Submission - BEIS request for responses on Flooding & Ecology

IP ref EA1N: 20024417

IP ref EA2: 20024418

Annex 1

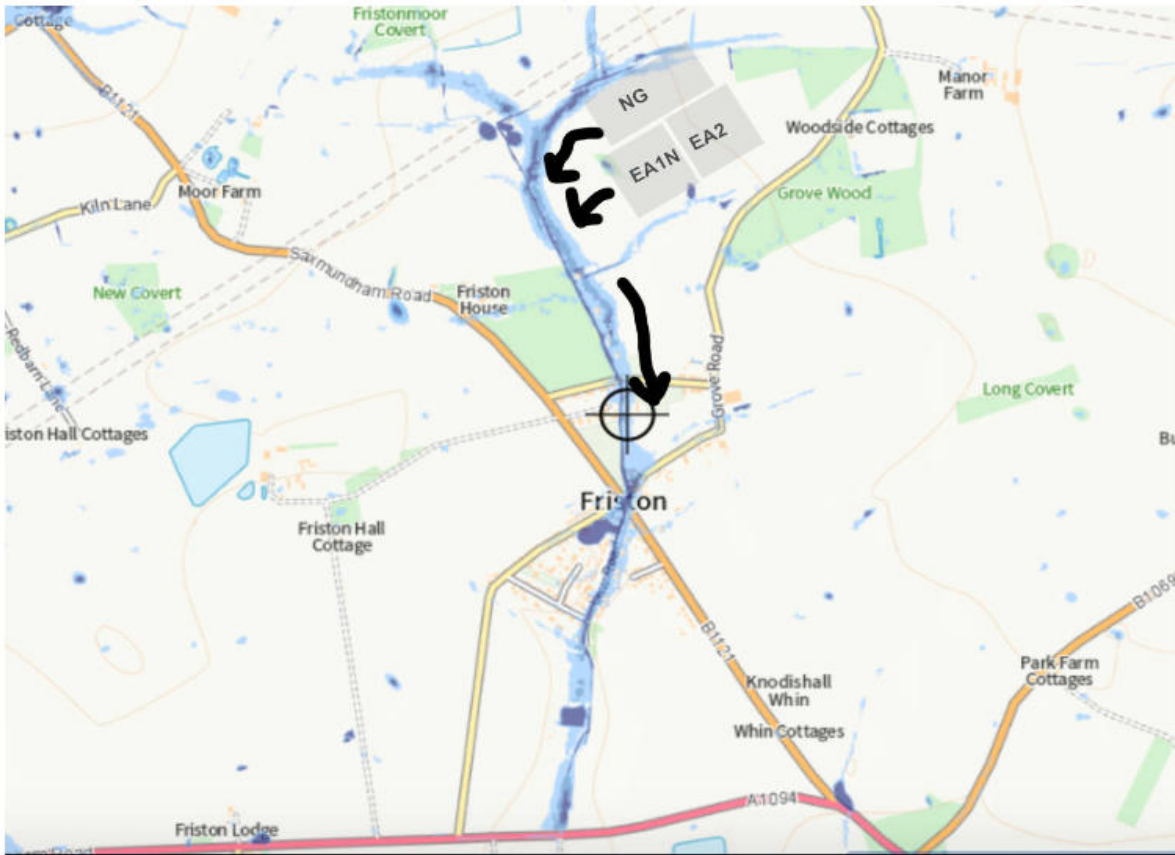
I live in Friston close to the water course/ditching to the north of the village. I have witnessed torrents of water flowing into the ditch from the fields to the north where SPR plans to build what will be a huge industrial complex. The Friston water course is not a river or a stream; it is little more than a ditch running through the village from north to south. This is joined in the middle of the village by other storm flows caused by water running off more fields on either side of Grove Road around the Church lane turning, flowing down the road into the centre of the village. I am informed much of the problem is the heavy clay below the top surface of the fields around Grove Wood, the water cannot get away fast enough and the current drainage system is breached whenever there is a significant amount of rain. This is illustrated by how SPRs archeology trenches, 75cm - 100cm deep, held water for days/weeks especially in those trenches along Grove road (see photographs Annex:1).

Archeology trench nearest to Grove road north of Friston water remaining 2 weeks after rain.

Archeology trench pointing towards Grove Wood 2 weeks after rain. Grove road runs to the right of this image.
